HYUNDAI Technical Service Bulletin	GROUP AUTOMATIC TRANSMISSION	NUMBER 23-AT-006H-1
	DATE AUGUST 2023	MODEL PALISADE (LX2) SANTA FE (TMA) SANTA FE HYBRID (TM/TMa HEV) SONATA (DN8A) SONATA HYBRID (DN8 HEV) TUCSON (NX4/NX4A) TUCSON HYBRID (NX4 HEV)
SUBJECT: AUTOMATIC TRANSAXLE PUSH-BUTTON SHIFTER DIAGNOSIS

This TSB supersedes TSB 23-AT-006H to add an additional applicable model, an additional diagnostic trouble code (DTC) P0706, and modify the service procedure on step 6.**

Santa Fe (TMa) 2.5L – (VINs begin with 5NM)

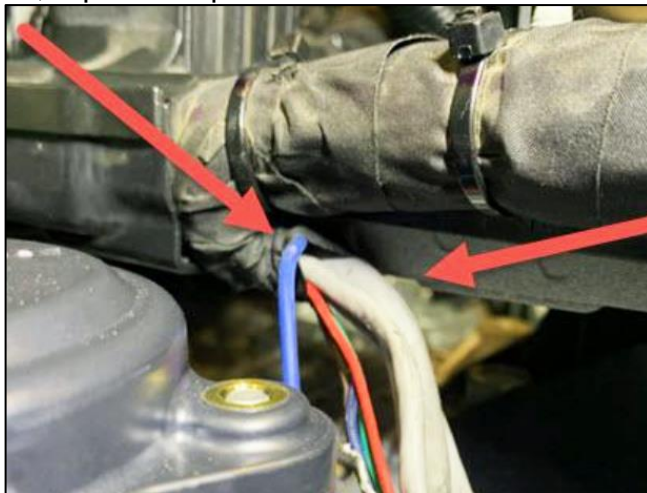
Carefully unwrap the harness protector in the area shown below. Check the insulation on the wires to see if the insulation has been damaged by contact with the battery tray. If so, repair or replace the control harness.

If replacing the control harness, make sure the replacement harness does not contact the battery tray/other components. Otherwise, the harness may become damaged again.
